## ADDENDUM

**ADDENDUM NO.:** 01  
**PROJECT NAME:** CIP Central Hearing Facility Roof and MEP Upgrades  
**PROJECT NO.:** 04044  
**CONTRACT NO.:** C1606  
**DATE OF ISSUE:** December 21, 2023

### NOTICE OF CHANGES, MODIFICATIONS, OR CLARIFICATIONS TO CONTRACT DOCUMENTS

**1 FOURTH FLOOR REFLECTED CEILING NEW WORK PLAN**  
SCALE: 1/8"=1'-0"

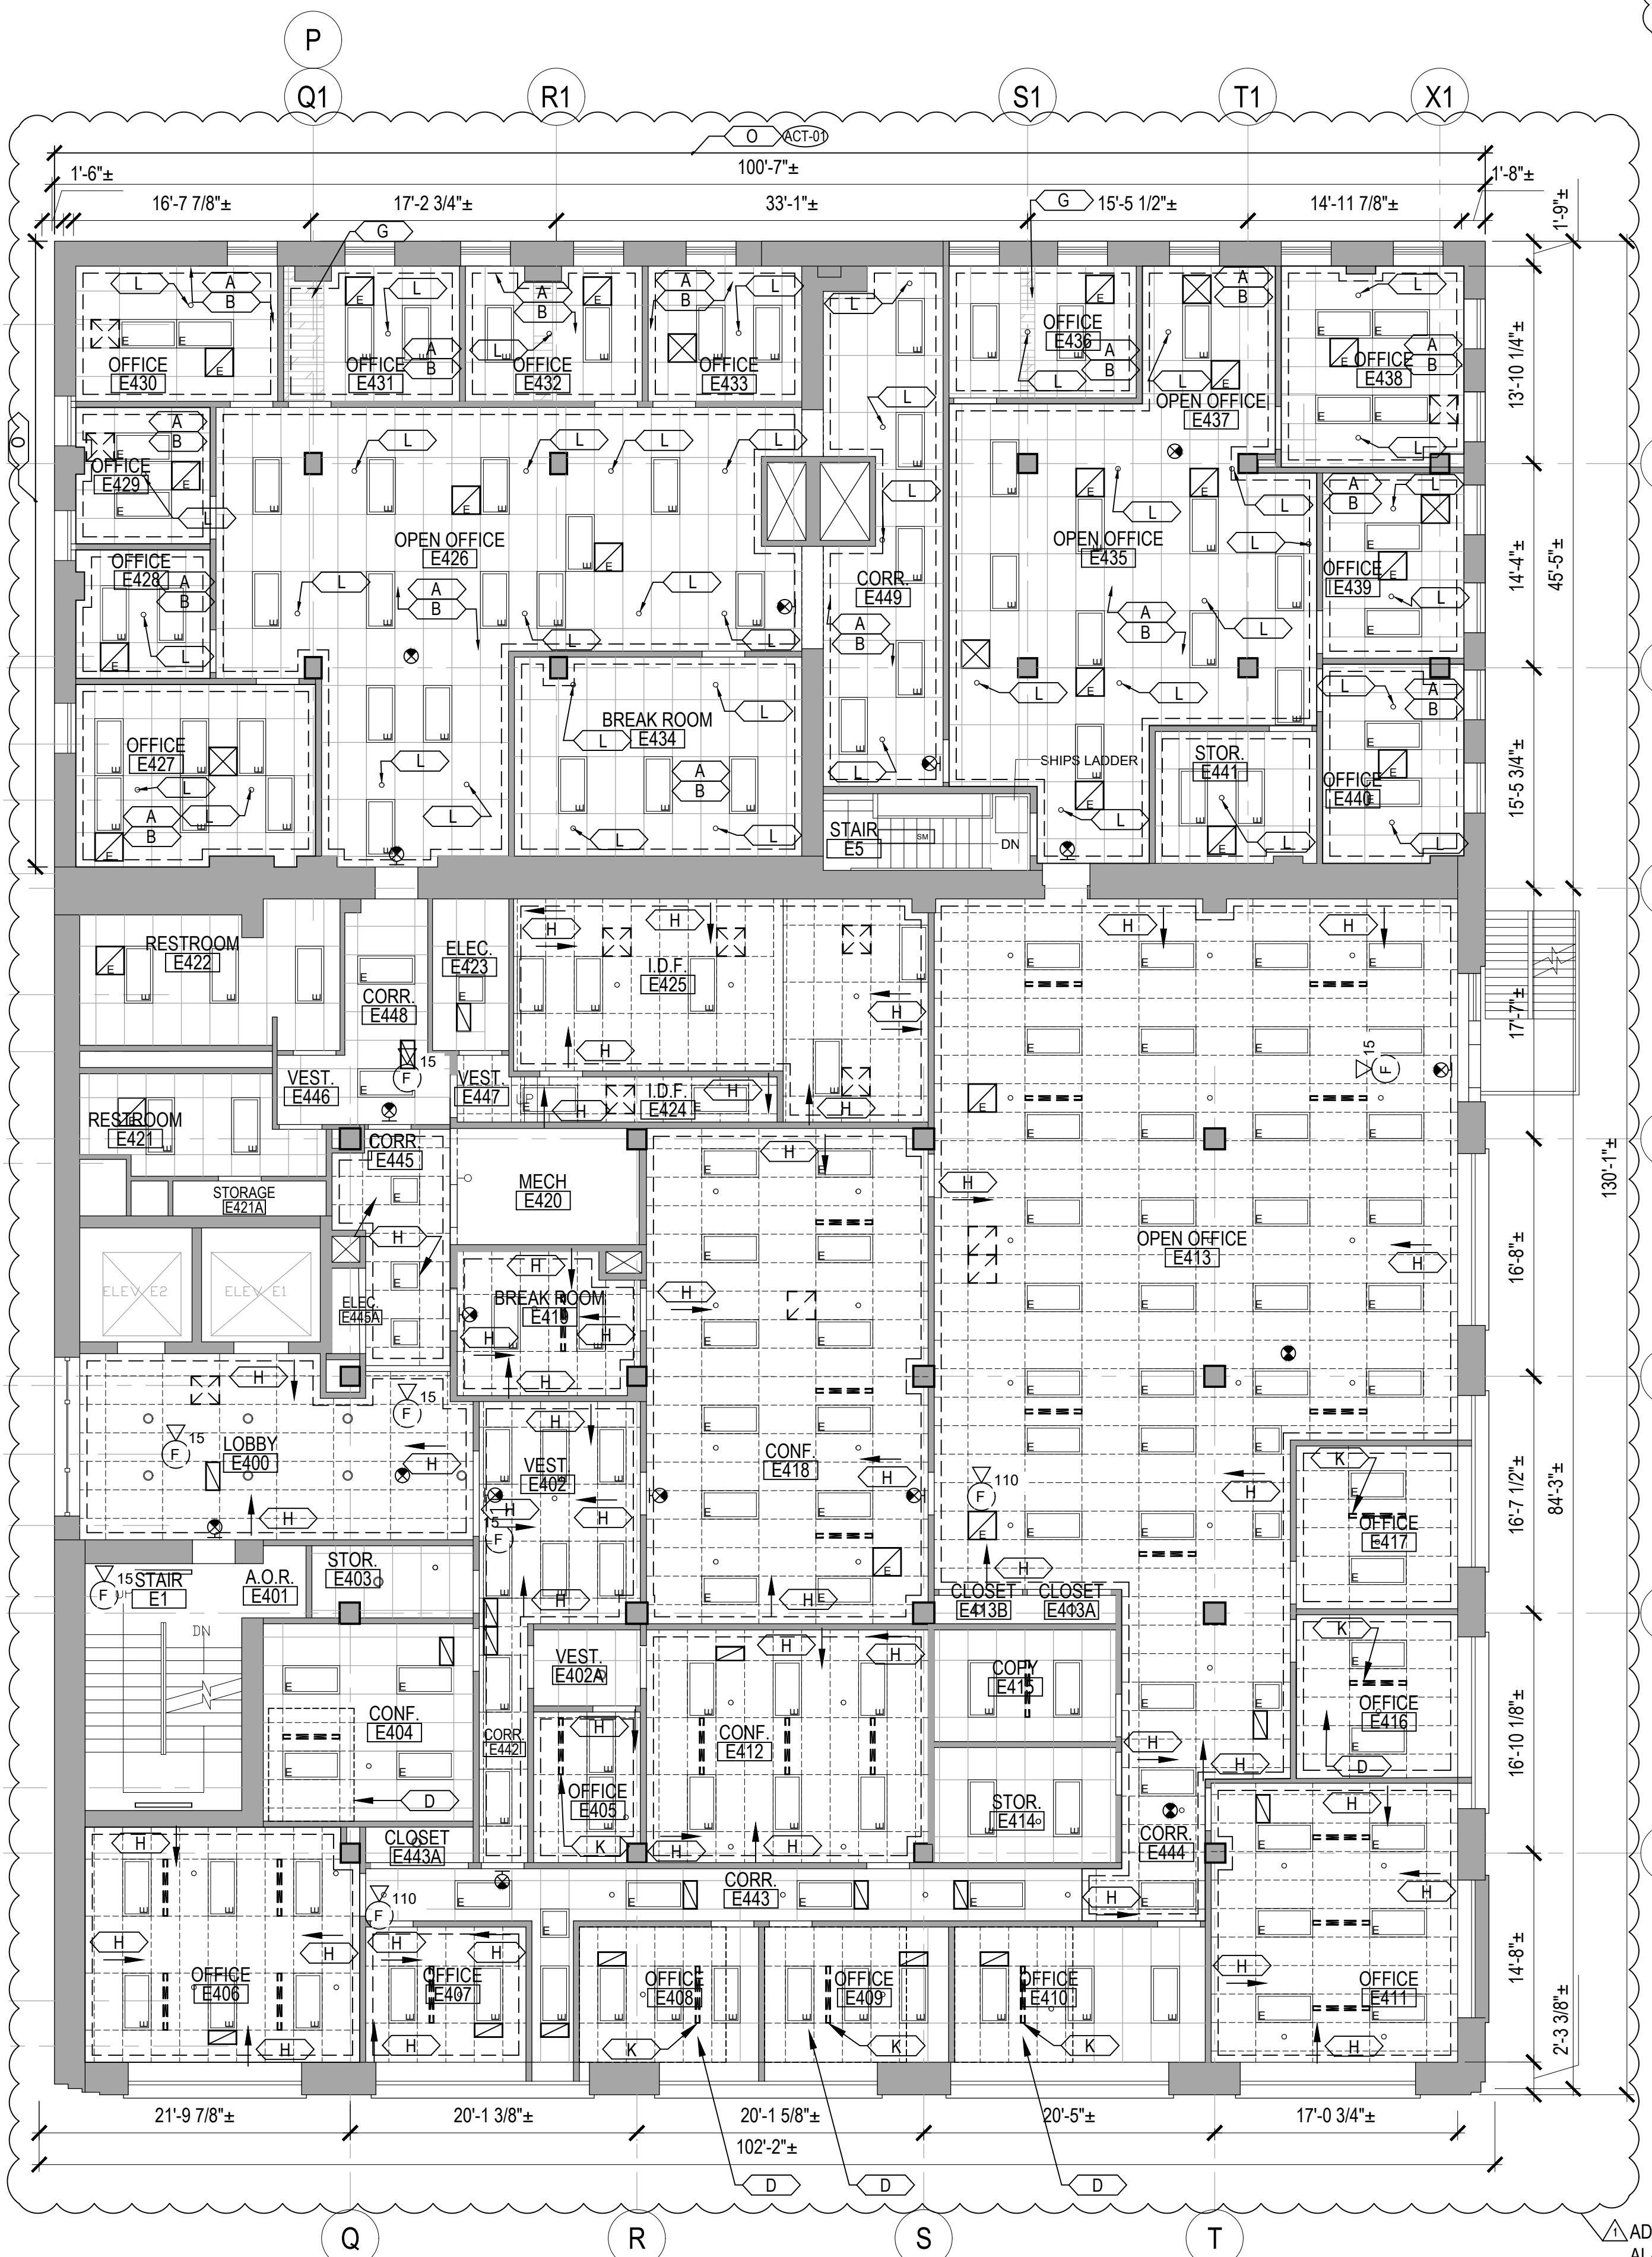
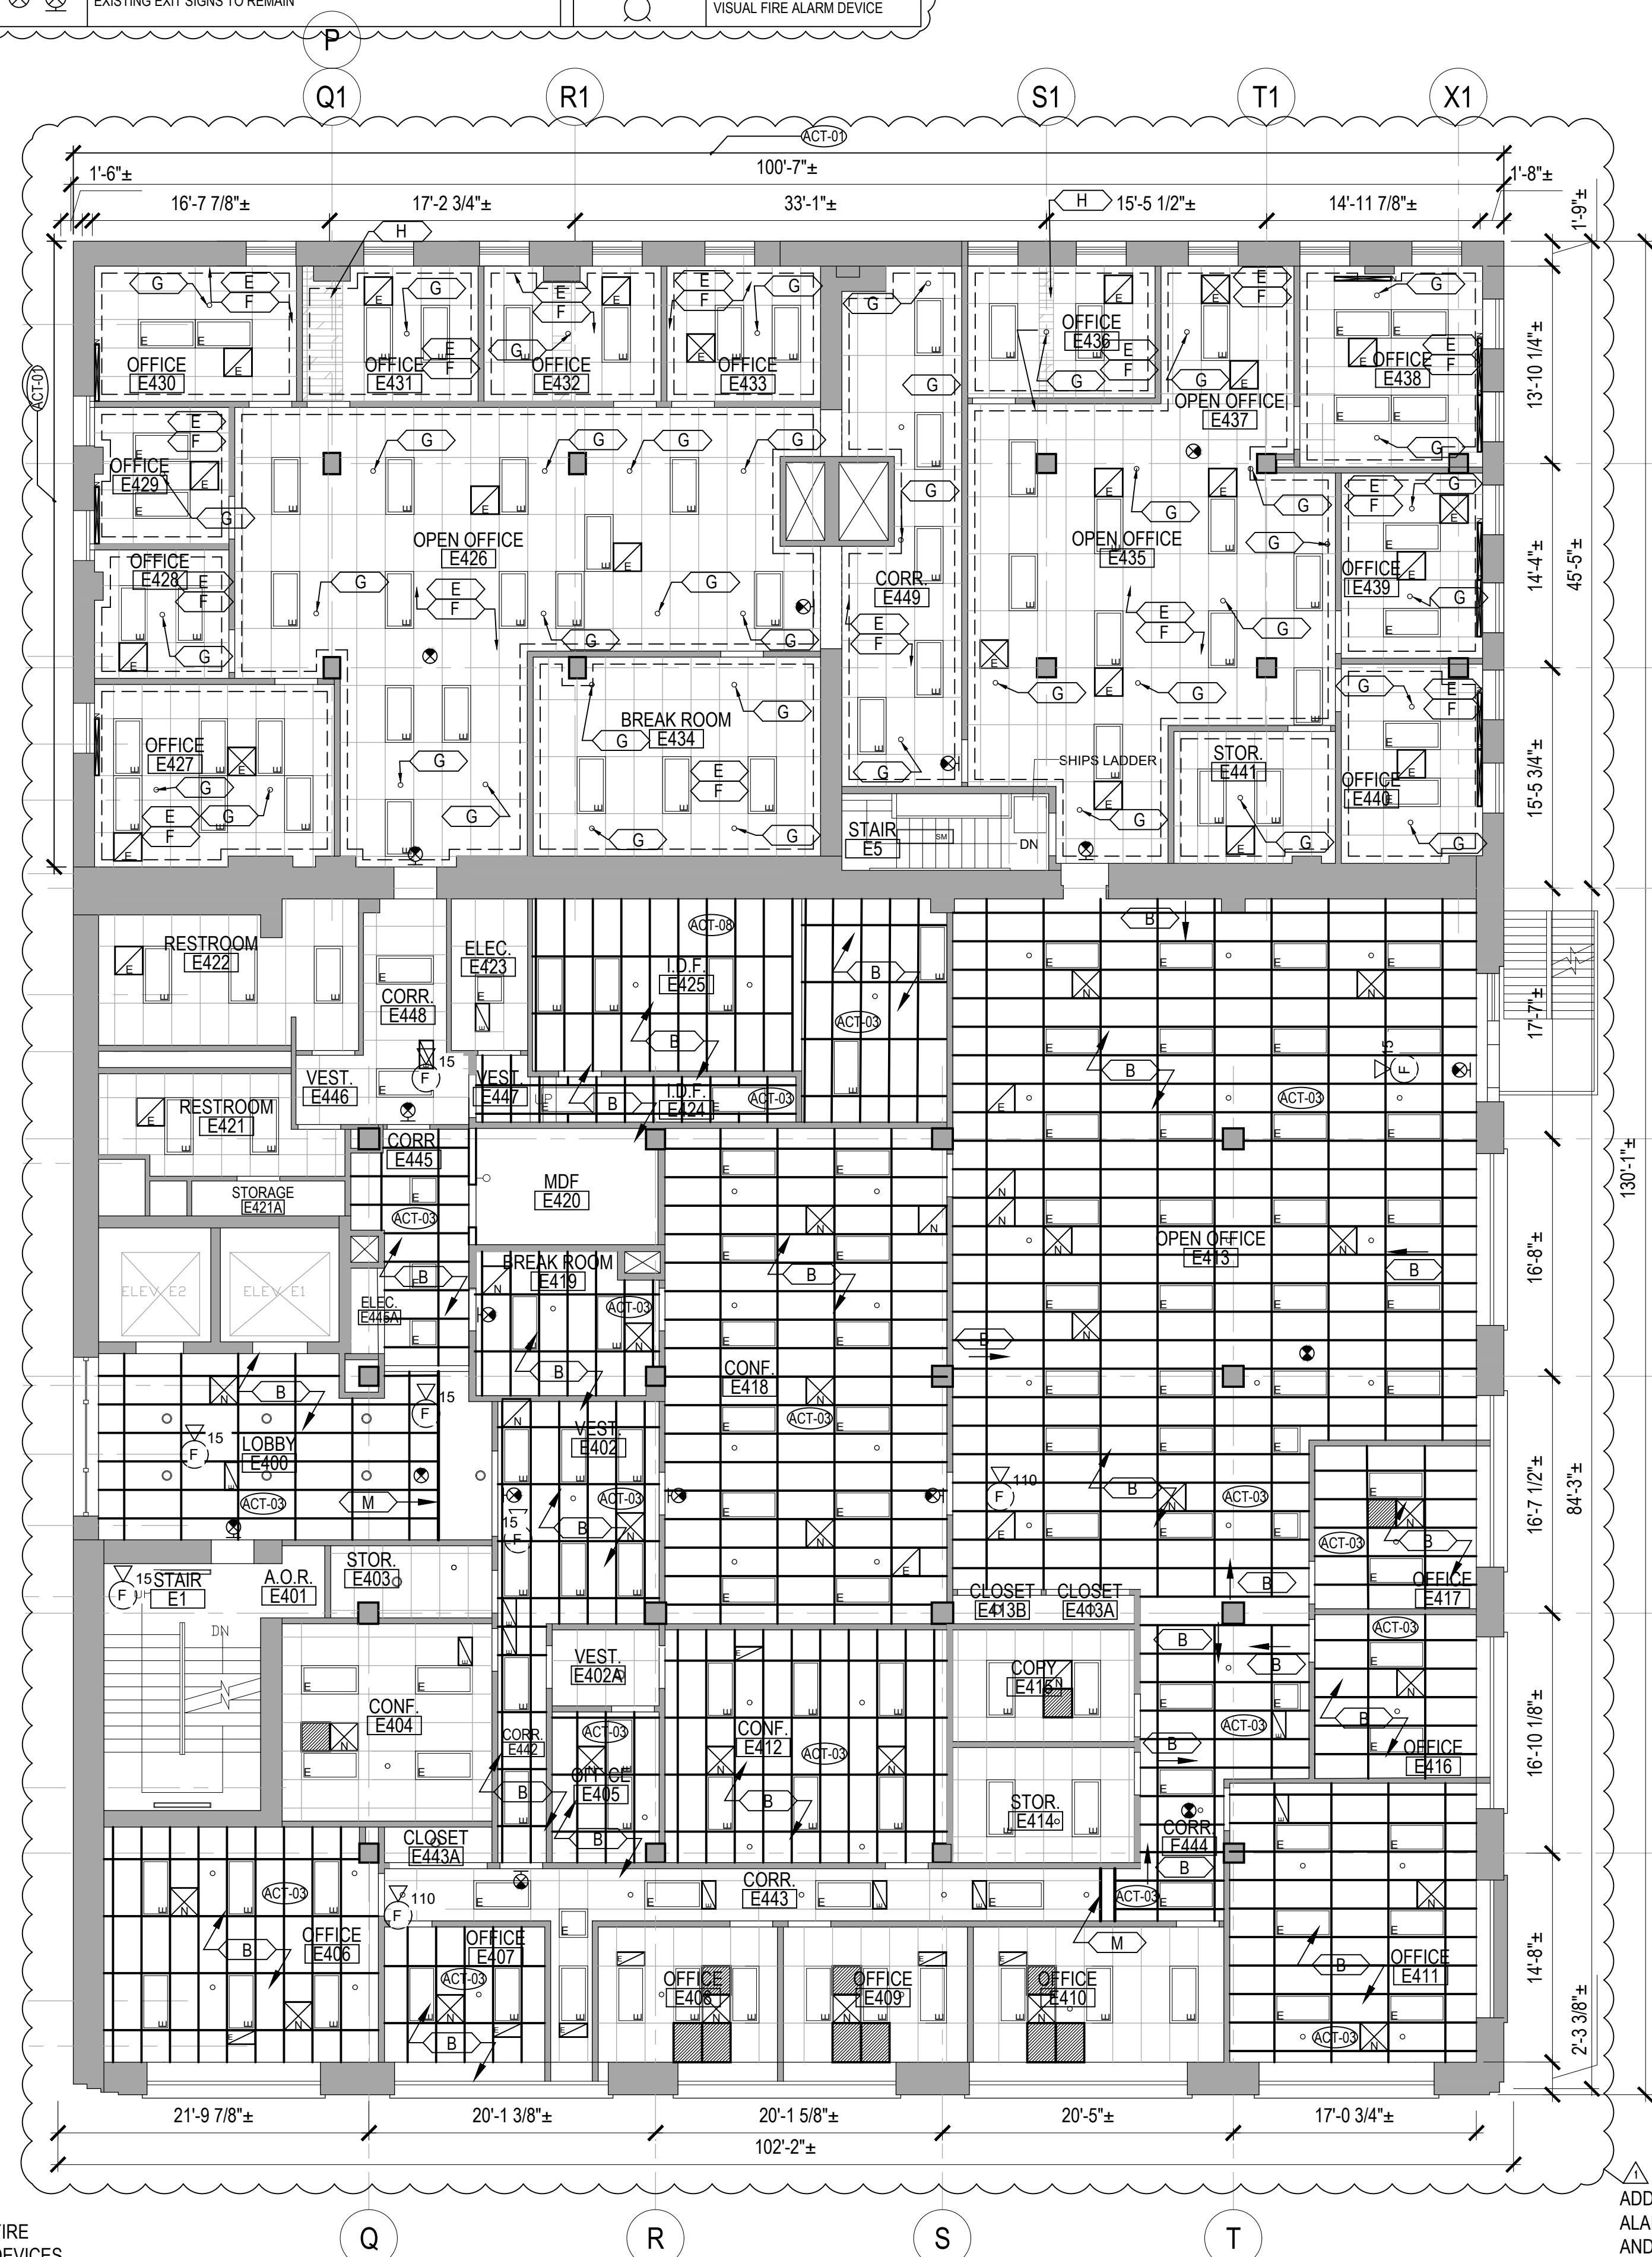
**Change 11** Drawing No. AC-103 –**REVISED** sheet to add existing ceiling hung devices. dated 12.21.23  
**Change 12** Drawing No. AC-104 –**REVISED** sheet to add existing ceiling hung devices, dated 12.21.23

**Question:** Sheet AC 104 confirm reflected ceiling plan demo keynote B and reflected ceiling plan new work keynote F only appear on AC 104 and are for this sheets work ONLY?

**Response:** Reflected Ceiling Plan Demolition Key Note B and Reflected Ceiling Plan New Work Key Note F are applicable to drawing sheet AC-104 only as shown in the Contract Documents.
